L-2018-223
10 CFR 54.17

December 14, 2018

Re: Florida Power & Light Company
Turkey Point Units 3 and 4
Docket Nos. 50-250 and 50-251
Turkey Point Units 3 and 4 Subsequent License Renewal Application Safety
Review - November 15, 2018 Public Meeting Action Item Responses

Revise Figures 4.5-1, 2, 3, 4, 5, 6 pages 4.5-4 – 4.5-9 as follows:

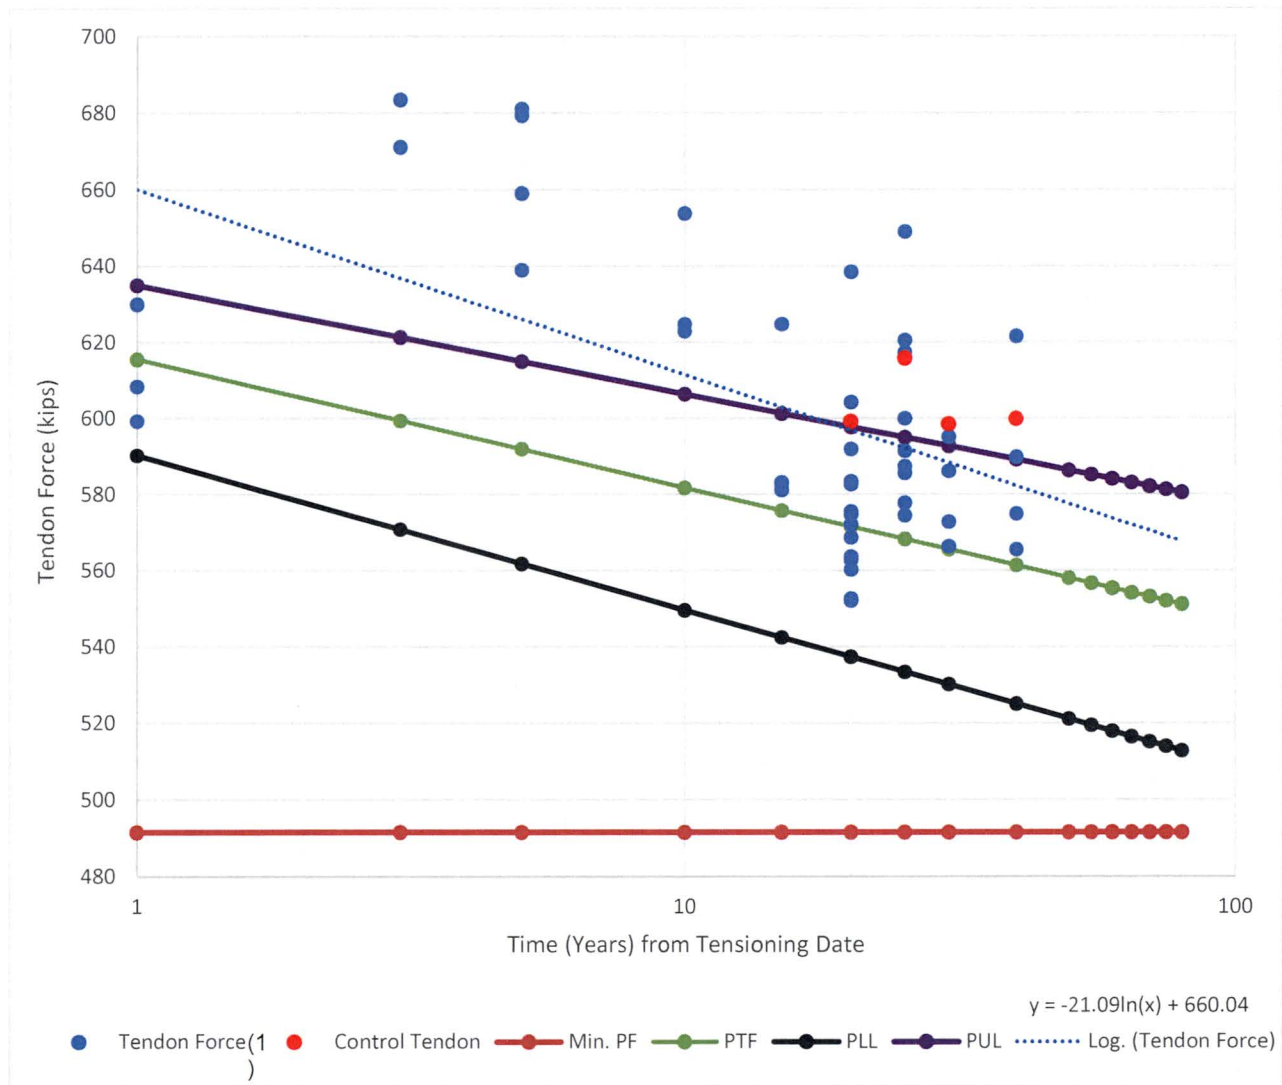
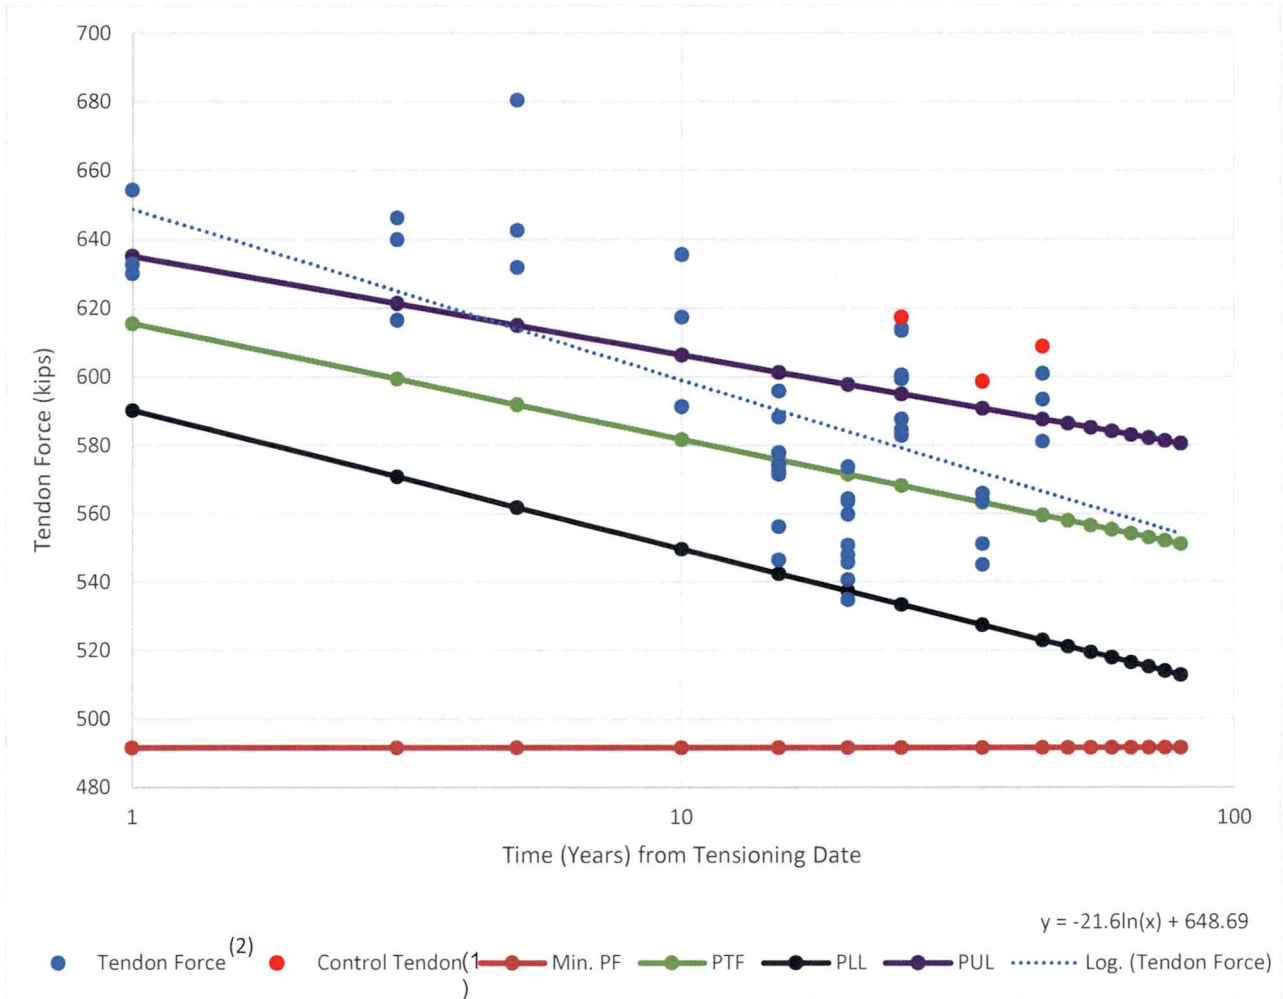
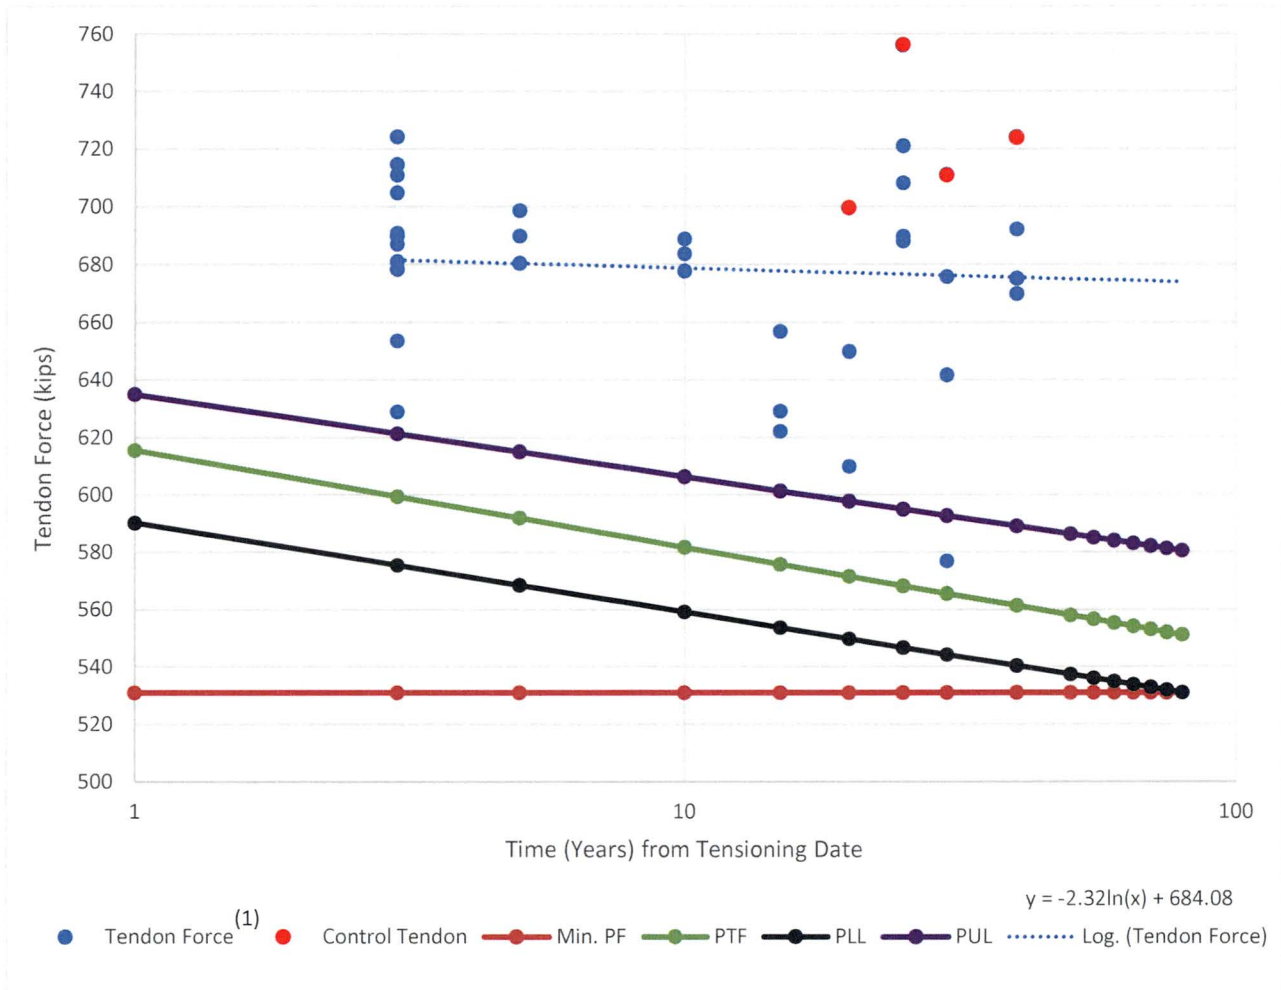
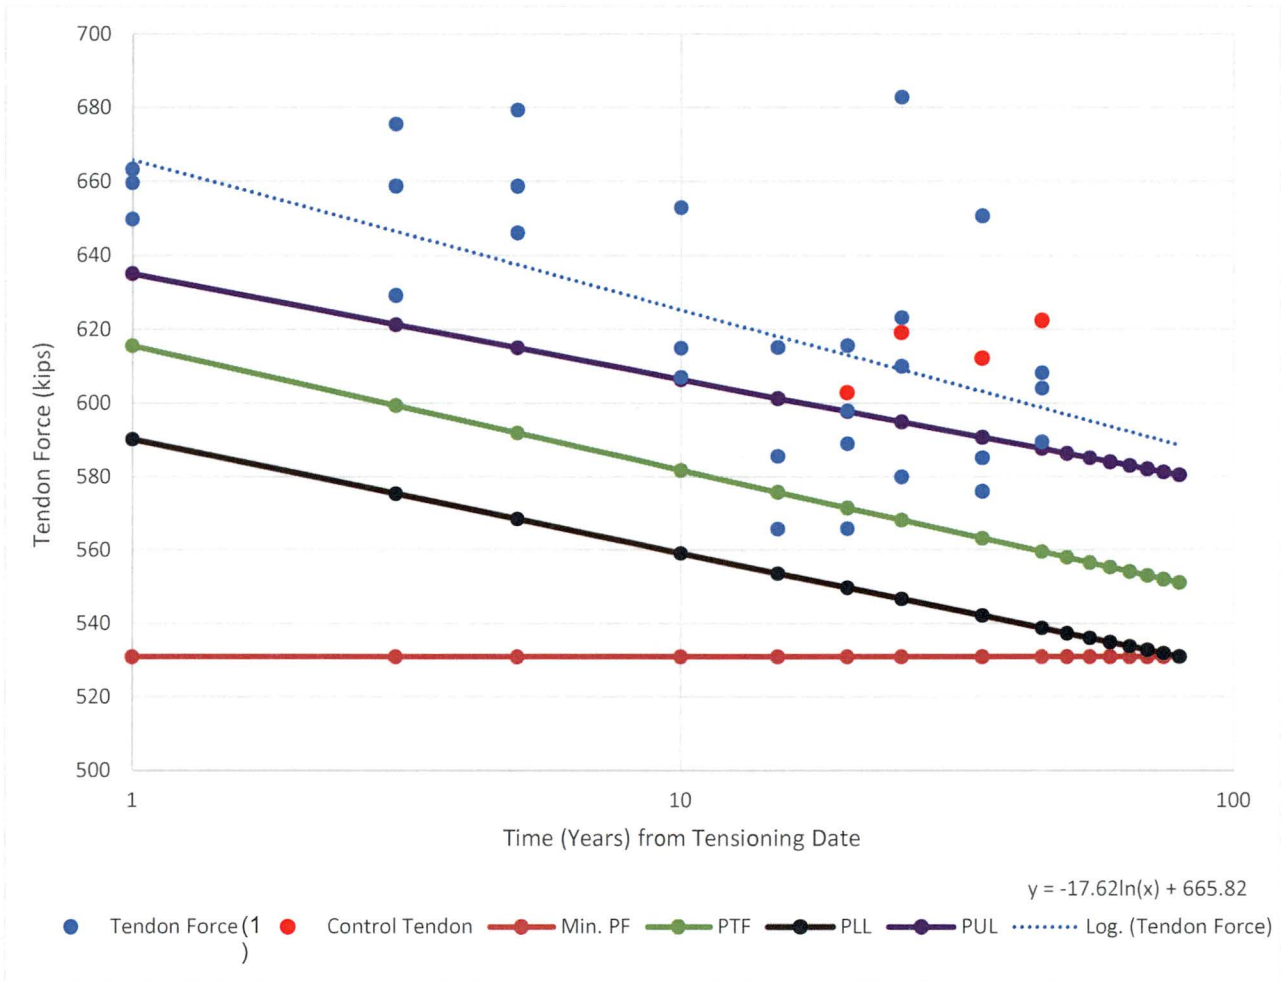
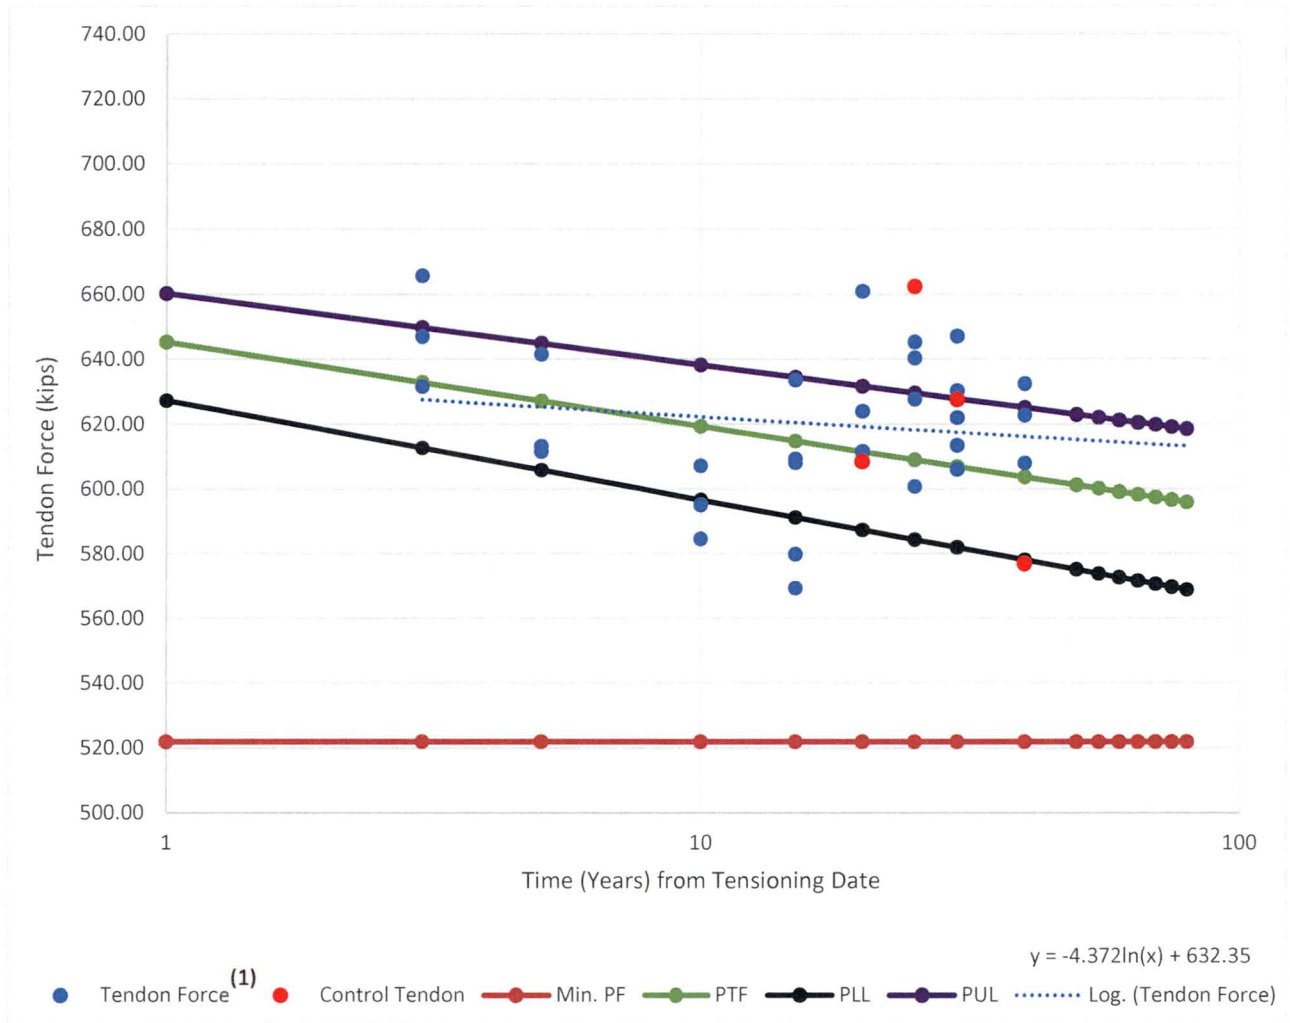
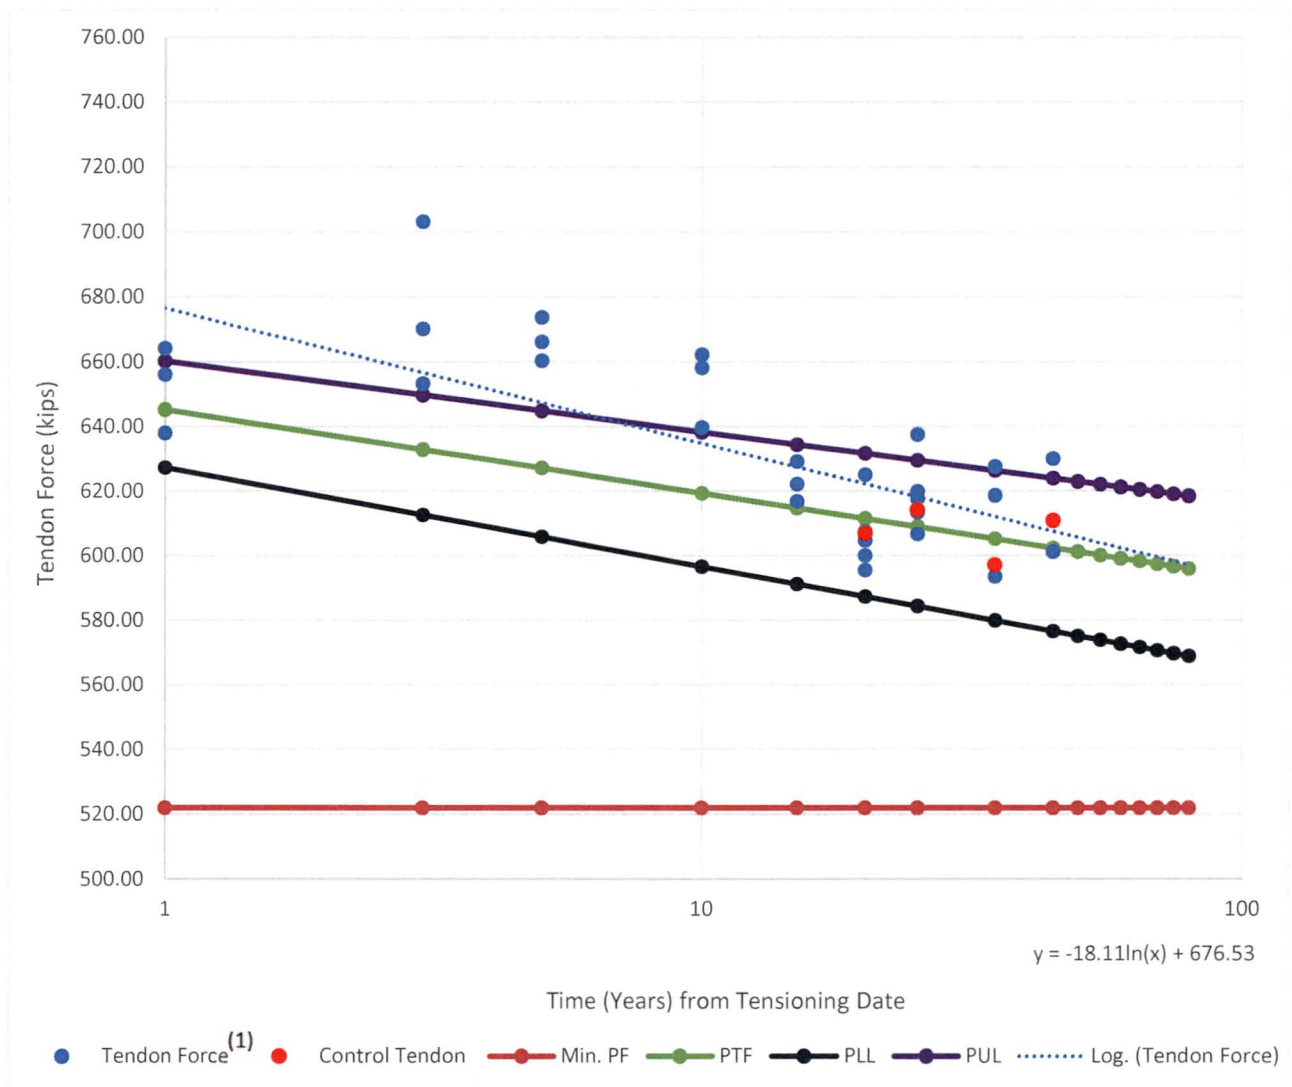
During the NRC site audit at Turkey Point from August 30, 2018 questions were raised regarding SLRA Section 4.5 Concrete Containment Tendon Prestress TLAA and the supporting calculations. These questions included clarification of:

In Figure 4.5-8, one result is listed for the Unit 4 hoop tendon 45th year (vs. the sample size of two) since one of the RVCH tendons (tendon 15H35) was surveyed as an alternate for the planned inspection RVCH tendon (tendon 15H32) that was determined to be inaccessible. The data for the alternate RVCH tendon (tendon 15H35) was not displayed in the TLAA Figure 4.5-8 since only average lift-off force for the tendon could be reported. The tendon lift-off data analyzed and presented in the TLAA for License Renewal (surveillance years 1-25) and the 30th and 35th years' surveillance reports is presented as normalized lift-off forces. The data in the 40th and 45th years' surveillance reports is presented as average lift-off forces. Instead of applying the Normalization Factor to the as-found lift-off force, the 40th and 45th surveillance report methodology applies the Normalization Factor to the Baseline Predicted Force. The 45th years' tendon selection and predicted forces report is used to convert the average lift-off force data to normalized lift-off force data by back-calculating the Normalization Factor from the Baseline Predicted Force. Since tendon 15H35 was not a planned inspection tendon, the predicted force (PF) and baseline predicted force (BPF) were not calculated in the tendon selection and predicted forces report. Therefore, the Normalization Factor could not be determined. The average lift-off force is greater than the PF and BPF; therefore, the tendon force is acceptable.

This response revises the audit follow-up response in Attachment 2 of FPL's November 2, 2018 response (Reference 1) as a result of discussions during the NRC public meeting on November 15, 2018 (Reference 2) related to further clarifications regarding the Concrete Containment Tendon Prestress TLAA. That response is superseded in its entirety for clarity. The conclusions in Reference 1 Attachment 2 were carried forward unchanged in this revised response.

- Added statement in the calculation and SLRA Section 4.5 that the PLL is evaluated as a TLAA.
- The tendon surveillance for Units 3 and 4 were performed at one, three, and five years after the containment Initial Structural Integrity Test, and every five years thereafter. In response to the NRC Final Rule 61 FR 41303 (Reference 4) which required implementation of the revised requirements for containment examination by September 9, 2001, FPL submitted proposed license amendments to incorporate the revisions to 10 CFR Section 50.55a(b)(2)(vi) (Reference 5). The revision to 10 CFR Section 50.55a(b)(2)(vi) states that ASME Section XI, Subsection IWL, as modified and supplemented by the requirements in Section 50.55a(b)(2)(viii), shall be used by licensees when performing containment examinations.

- The Turkey Point Unit 3 and Unit 4 RVCH Replacement Projects required a containment access opening consisting of the removal and later replacement of a section of the containment structures. The Unit 3 and Unit 4 tendons affected by the RVCH modification are considered as augmented scope tendons and are analyzed separately from the Unit 3 and Unit 4 tendons for SLR. The tendon loss of prestress calculation was updated to separate the augmented scope tendons from the original scope tendons which eliminated the considerable tendon lift-off force variation.
